# Smithfield - LH 'FRENCH COUNTRY'

8 HNC - 113 Eagle Crest Court, Lillington, NC 27546

7-30-24 - Initial Redlines - JJ

THE SMITHFIELD - LH  
Cover Sheet 'French Country'

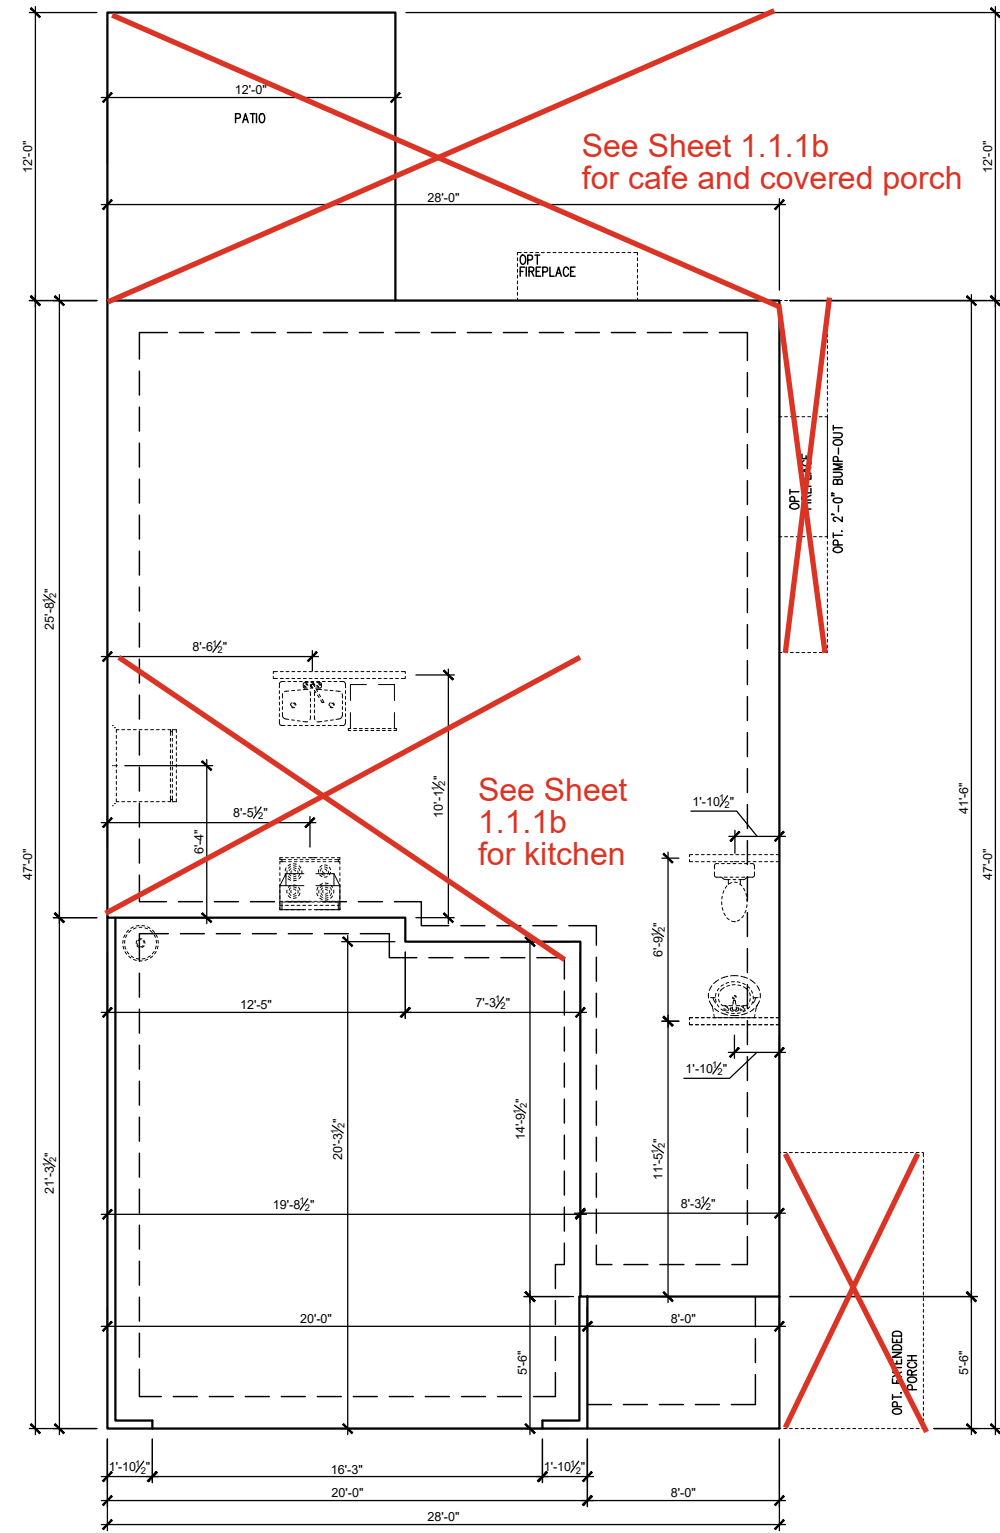
2130 heated  
620 unheated  
2750 total

**FIRST FLOOR PLAN 'FRENCH COUNTRY'**

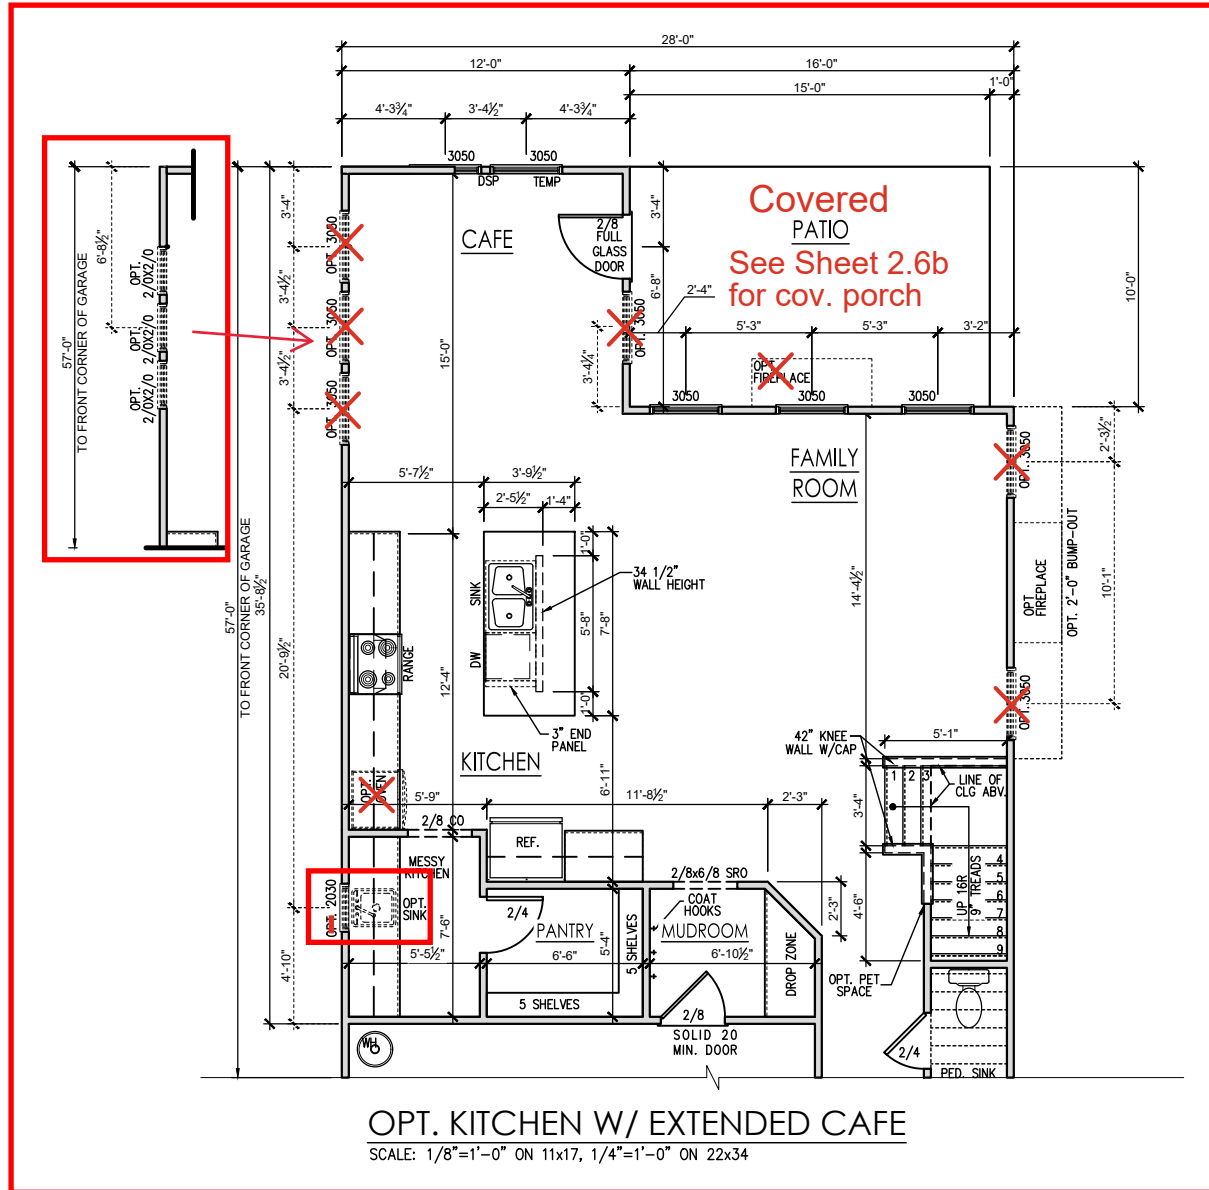
See Sheet 2.1.1b for cafe and kitchen

See Sheet 2.6b for cov. porch

**SECOND FLOOR PLAN 'FRENCH COUNTRY'**  
SCALE: 1/8"=1'-0" ON 11x17, 1/4"=1'-0" ON 22x34

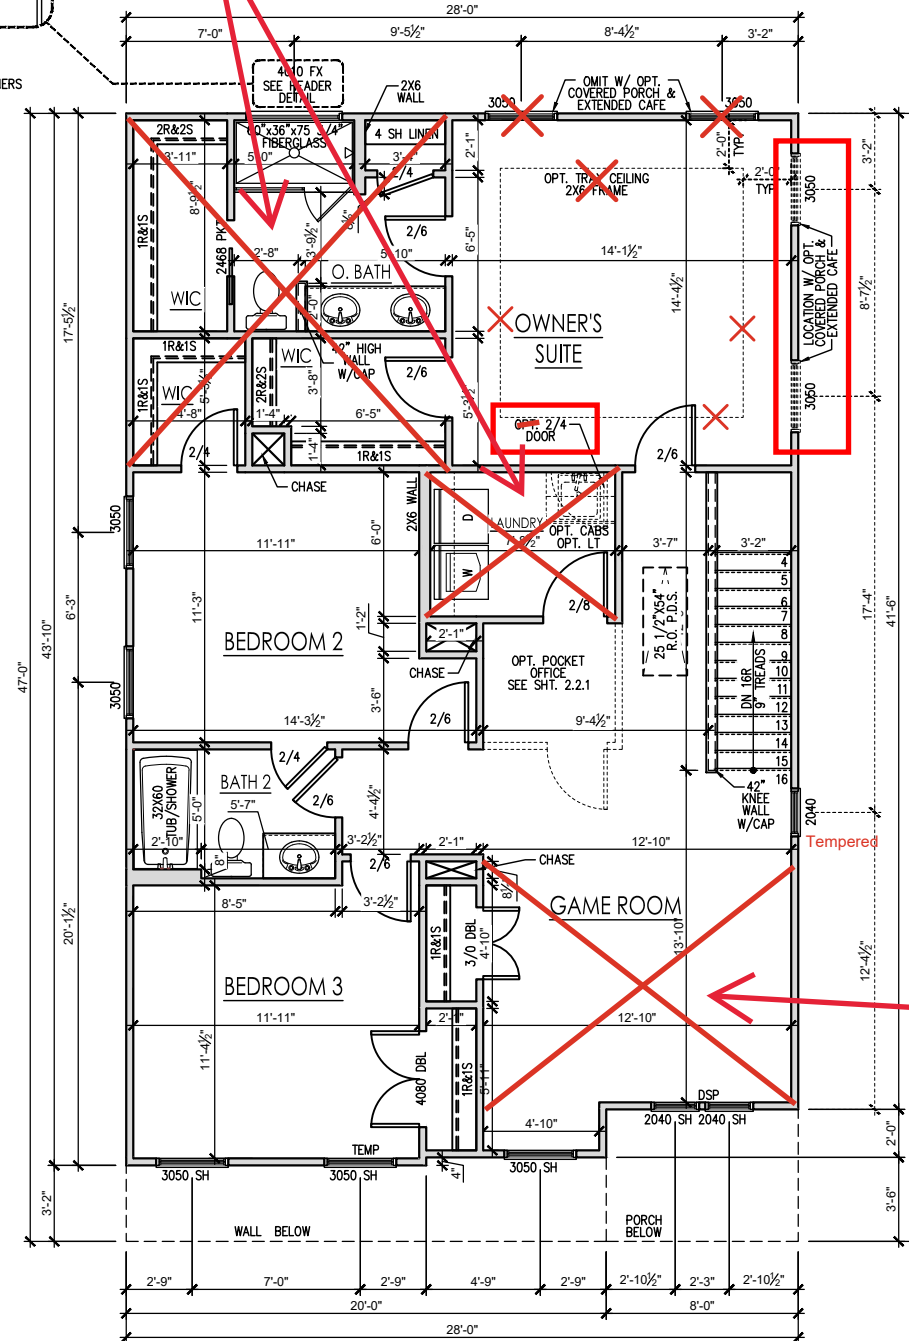
See Sheet 2.2.1b for Owner's Bath, WIC, Laundry and Bedroom 2 closet

See Sheet 2.2.1b for 4th bedroom
